Town of Hilton Head Island Regular Design Review Board Meeting

Tuesday, July 28, 2015

AGENDA

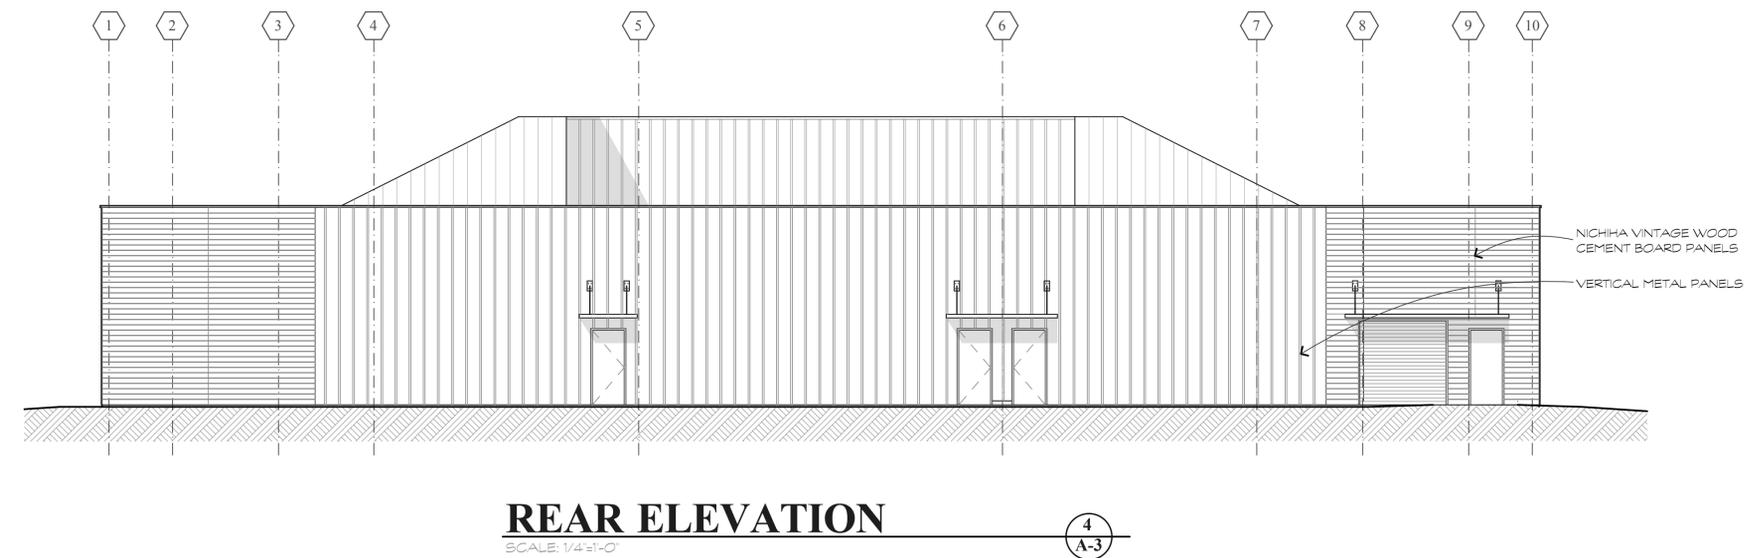
All facades are have equal design characteristics	<input type="checkbox"/>	<input checked="" type="checkbox"/>	<input type="checkbox"/>	Rear elevation (facing Kroger rear elevation) does not have eq. design characteristics.
Avoids monotonous planes or unrelieved repetition	<input checked="" type="checkbox"/>	<input type="checkbox"/>	<input type="checkbox"/>	
Has a strong roof form with enough variety to provide visual interest	<input type="checkbox"/>	<input checked="" type="checkbox"/>	<input type="checkbox"/>	Appears mostly flat, especially against flat backdrop of Kroger rear elevation.

7 EQUIPMENT ENCLOSURE - TRELLIS DETAIL
1/4" = 1'-0"

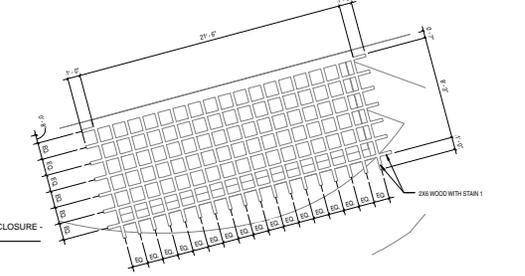
1. Consider shaped ends on trellis members to match or complement existing trellis details.
2. Consider darker fabric awnings (i.e. Sand or Toasty Beige versus Ivory) to provide less contrast.
3. Consider more variety of shrubs in landscape beds.
